UNITED STATES OF AMERICA  
NUCLEAR REGULATORY COMMISSION

_____ )	
In the Matter of )	Docket No. 40-8838-MLA
U.S.ARMY )	ASLBP No. 00-776-04-MLA
(Jefferson Proving Ground Site) )	July 13, 2007
_____ )

**INITIAL STATEMENT OF POSITION OF INTERVENOR SAVE THE VALLEY, INC.**

Figure 1. Reversible  
Exchange with Stream

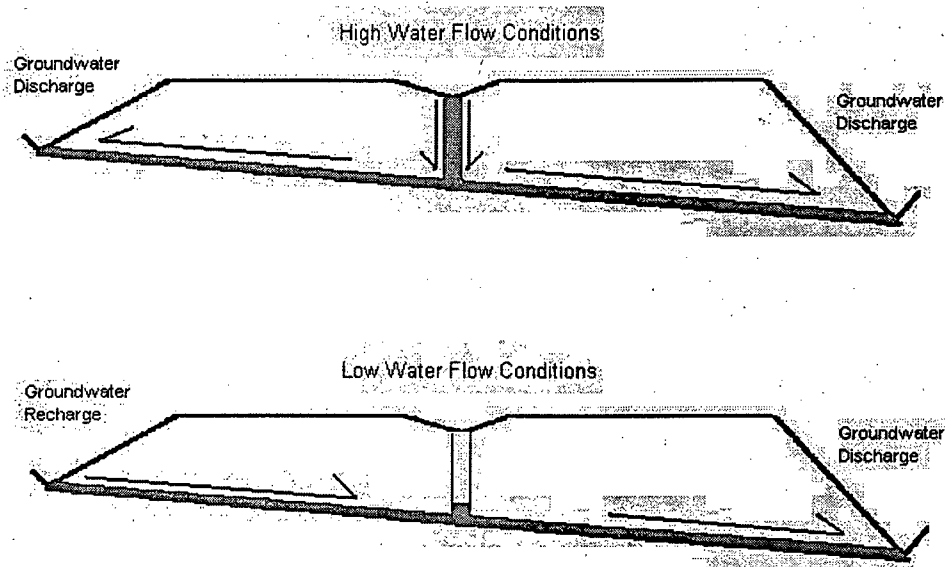
The deficiency in the surface water gauging and staging tasks is that the premise of the current conceptual model is that there *is* karst flow underlying the JPG DU site. The objective of the characterization is the same, *i.e.*, provide the fate and transport modeling with an accurate description of how much groundwater flow is carrying how much DU how quickly from the impact area to the locations of potential exposure. But, groundwater no longer is conceptualized as simply moving toward and into the local

streams, driven by in-basin topography. A karst network may discharge groundwater to the local stream. But, a karst network may recharge with water taken from the local stream, transport it through the karst system of the bedrock and discharge it back to the stream downstream of the surface water monitoring network. A karst network may also recharge with water taken from a local stream and discharge it to a stream in an entirely different basin. Karst groundwater and DU in or transported by that groundwater is undetectable by a gauging and staging system designed for non-karst hydrogeology when the karst system which actually exists discharges outside the confines of the surface water monitoring system.

This deficiency is further complicated because the interaction of a karst network and surface water drainage can and often does change temporally. Figure 1 shows a schematic of a simple karst network and how it can change with respect to its impacts on streams that it intersects. During high recharge conditions, groundwater in the karst network is recharged from precipitation and discharges to both streams. However, during low water flow conditions, the karst system recharges from precipitation and from the stream with the higher elevation and discharges only to the lower stream. Stream-flow separation of gauging data on either stream will produce an erroneous interpretation of the aquifer recharge unless the location and the transient nature of the karst interaction are known. The gauging and staging tasks proposed in the FSP and related addenda cannot account for even such a simple transient interaction and cannot, therefore, provide the data to the fate and transport model that is needed.

**A.037** The stream/cave gauging and stream staging activities in the modified FSP are not designed to document and quantify groundwater and surface-water interactions. Such a design is fundamentally needed to generate the data that are meaningful to the fate and transport modeling required to support site decommissioning. Achieving a design capable of supporting a decision on site decommissioning will require work not presently in the modified FSP.

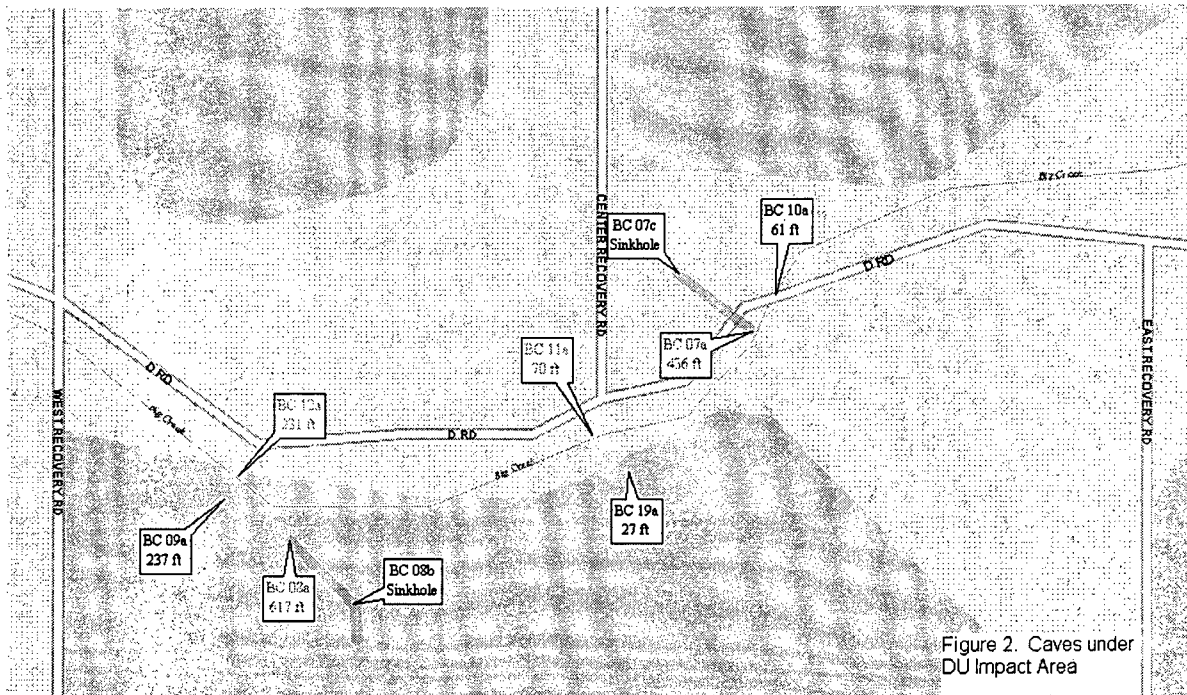
- The modified FSP does not require wells to be installed when aquifers are found in the unconsolidated sediments above the bedrock. Any such permeable zones that are encountered will have a fundamental impact on directions and rates of migration in the unconsolidated sediments and, therefore, similar impact on reduced attenuation of uranium migrating through the soils. Understanding these

- Failure to verify the FTA/EI approach with the patterns and existence of known conduits and sink holes is an additional deficiency. Comparing the cave traces on Figure 2 with the fracture traces from the FTA (Figure 3-1, page 3-2 of Addendum 3) shows that the longest mapped cave under the DU impact area, BC-08, is not coincident with a fracture trace. Clearly the FTA doesn't identify all, if any, of major shallow groundwater conduits. The second longest mapped cave, BC-07, may be associated with a fracture trace and the sink hole entrance may be associated with the intersection of two fracture traces. However, there is no low-resistivity anomaly on the EI survey where the fracture trace or the cave crosses the road and no EI survey was done around the intersection of the fracture traces away
